161 SUSSEX ST REDEVELOPMENT

SECTION 96 (2)
REV: C

25 March 2014

DESIGN STATEMENT

WESTERN FAÇADE – CONVENTION

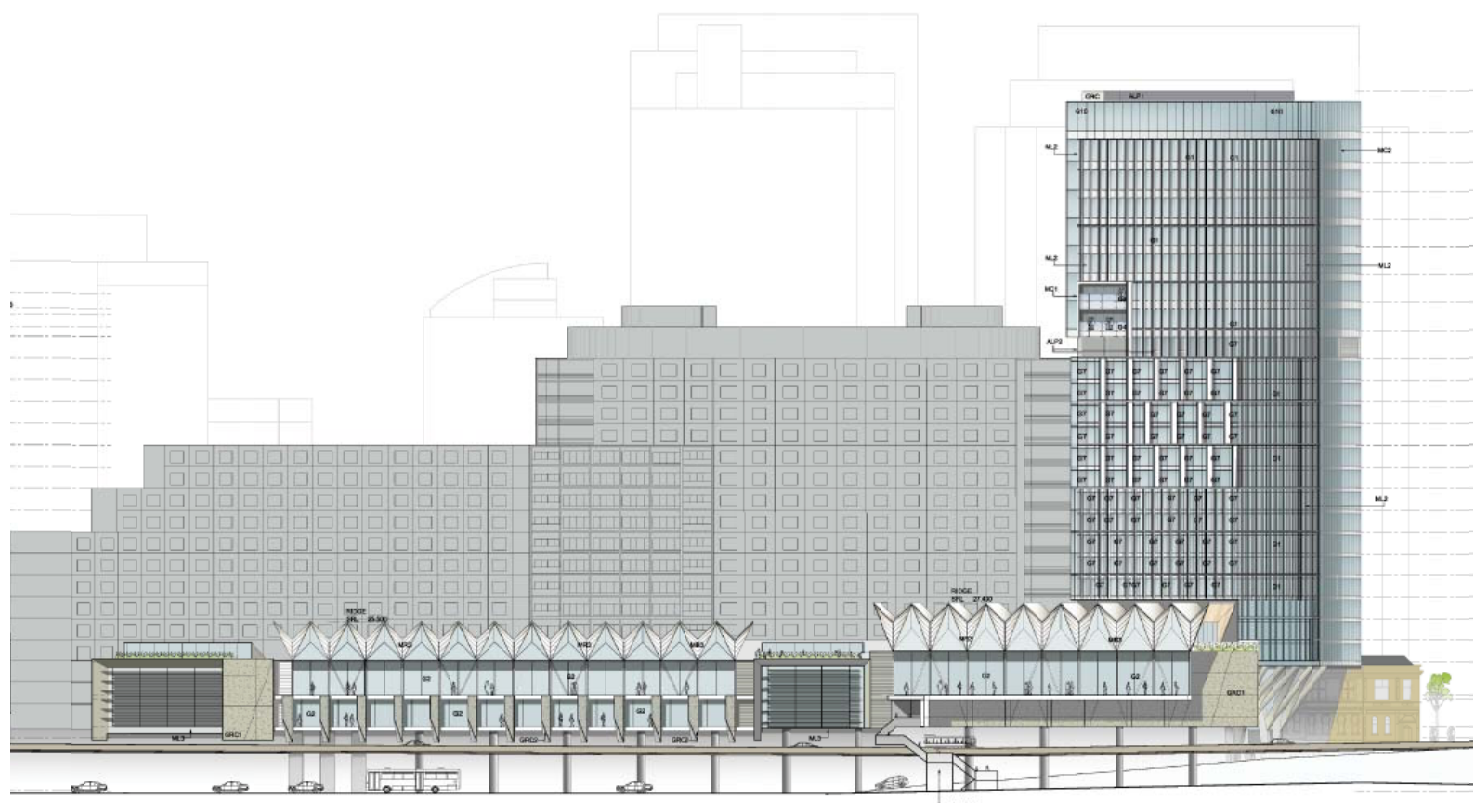
The horizontality of the building has been enhanced through consideration of structural issues. Deep spandrels now describe more boldly the horizontal datums. The façade is now better modelled to cast a deep horizontal shadow across the west façade. The 'heavier' appearance of the spandrels anchors and gives mass to the building, better integrating it with motorway infrastructure.

All western façade shading systems are now integrated in the façade design, as opposed to having a 'tacked on' appearance as per the approved west façade design.

Façade maintenance methodology across the convention building has also been carefully considered. The maintenance regime is now integrated in the façade design. It has no physical presence – recesses in the façade are included to conceal BMUs from public view. Most critically, façade maintenance and cleaning can now be conducted in a safe manner and without the requirement for closure of the Western Distributor.

The material selection and application has been refined and improved in quality. The proposed facade materials to the convention building comprise equitone panels, flat-lock expressed seam zinc sheeting, limited white metal panel and extensive closed-cavity glazed facades. The closed-cavity glazed facades (triple glazed units with interstitial blinds) will ensure western solar penetration and acoustic amenity are addressed, while also ensuring views over Cockle Bay are maximized.

VIEW OF THE THROUGH SITE LINK FROM HOTEL FOYER

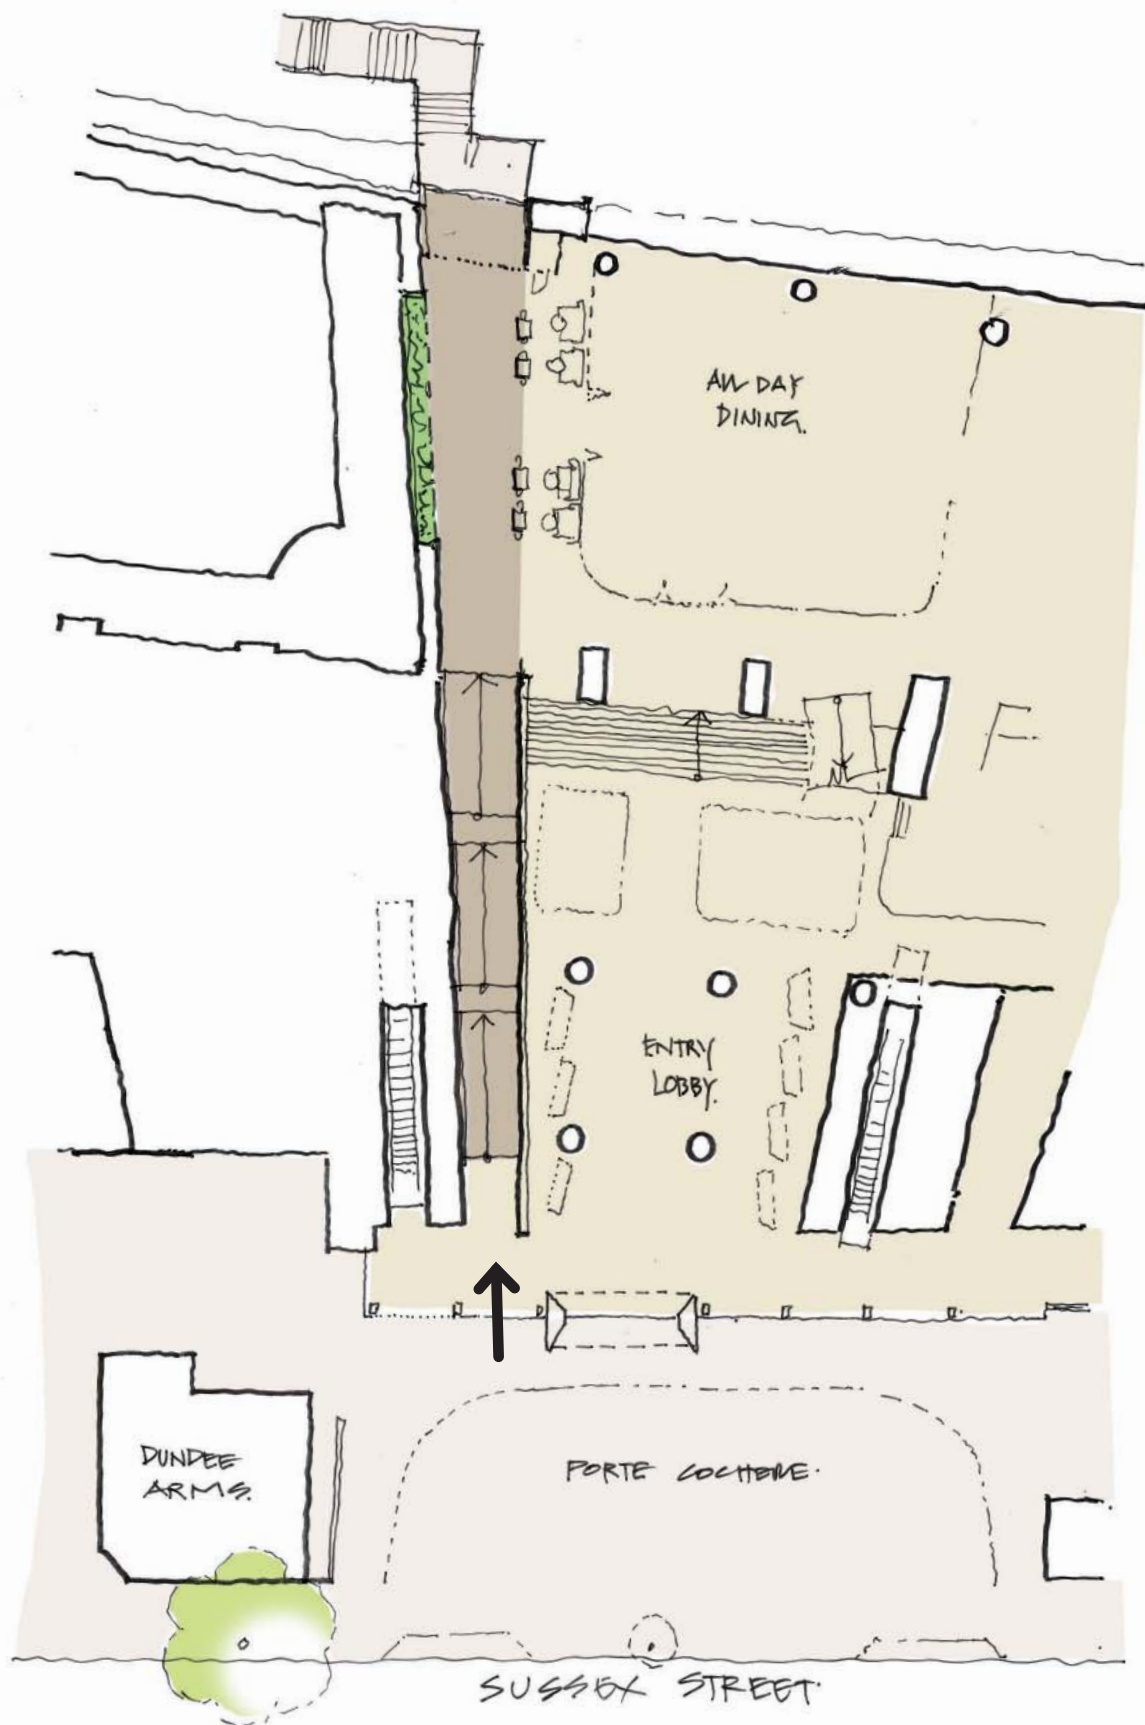
After stakeholder consultation - in particular with RMS - it has been determined that the inclusion of the accessible lift and the escalator pit is not feasible over the Western Distributor given clearances required for the motorway envelope.

This has necessitated the re-design of the through site link. The proposed link is now a series of accessible ramps which connect the two different levels of the foyer (approximately 1.5 metres difference). The route remains in the approved location with direct access from the hotel entry to the existing stair at Wheat Road

The through site link will be made legible and distinct in the development of the interior finishes, lighting, signage and detailing approach. In addition the design has integrated a green wall adjacent to the all-day dining restaurant. The restaurant provides an activated edge to the link and provides for passive surveillance.
